Datganiad Tystiolaeth

Cwm y Nant, Dafen, Llanelli

Cyfeirnod CDLI Adneuo Diwygiedig – PrC2/h22

Ymatebion gan CNC, Dŵr Cymru a Phrifffyrdd i'r ymgynghoriad mewn perthynas â Chais Cynllunio
S/40692

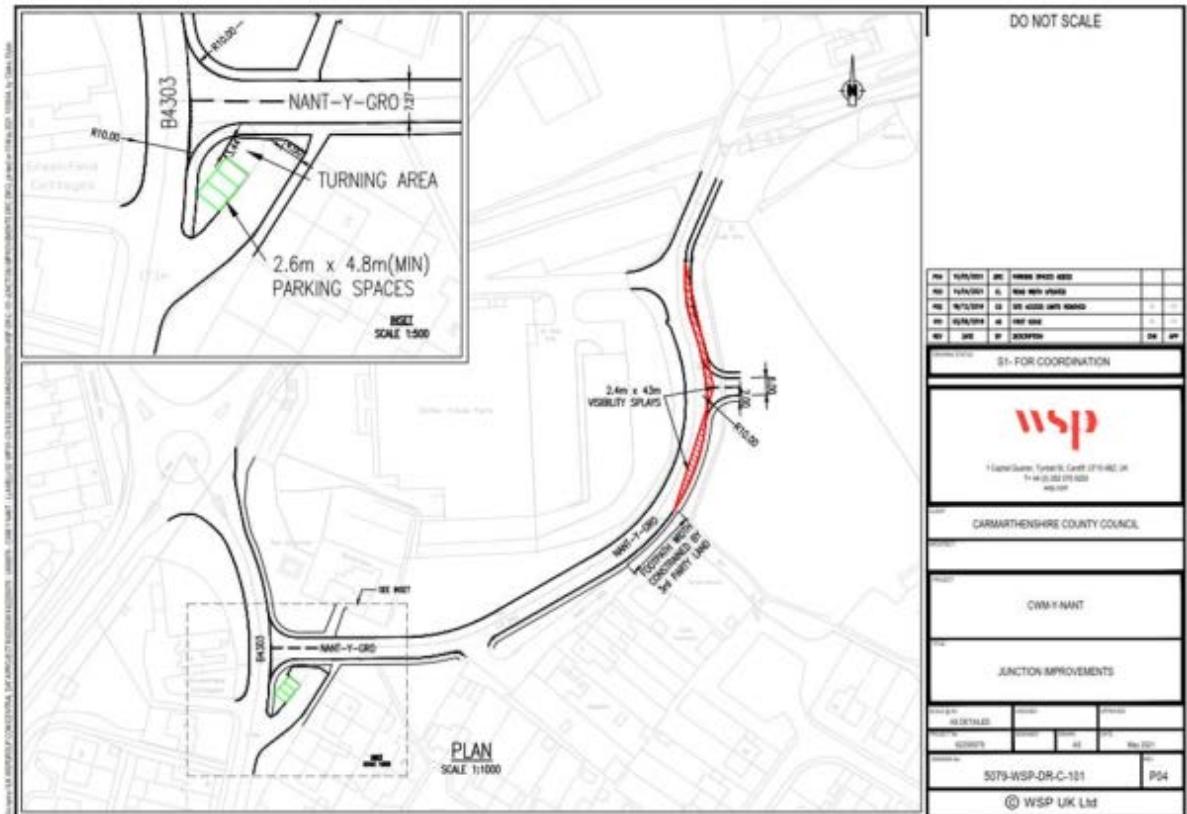
The site layout is indicative at this stage and will be confirmed at reserved matters stage. However, the applicant has indicated the following:

- Vehicular parking will be provided at the Cwm-y-Nant development in the form of on and off-street provision, in line with CSS Wales Parking Standards.

- A suitable condition which requires a holistic scheme for Active Travel provision (both within the site and connecting to surrounding routes) would ensure the development is Active Travel compliant and would provide an element of certainty under the relevant tests.

Highways Planning Liaison recommend that the following elements form part of the Active Travel Scheme for the site in order to maximise opportunities for travel by active modes:

- A shared path link from Gorsfach connecting to the main body of the development site and to Nant-y-Gro.
- Greenways (or similarly appropriate designs) to be provided on site should the tree avenues currently proposed (as shown in the indicative site masterplan) form part of the final site layout.
- A shared path link from the proposed attenuation pond / play area to the A4138 cycle route.
- Provision of footways / shared use path along the north site of Nant-y-Gro; connecting the site to the Dafen Roundabout underpass thus linking with the Llanelli Strategic Cycle Network.
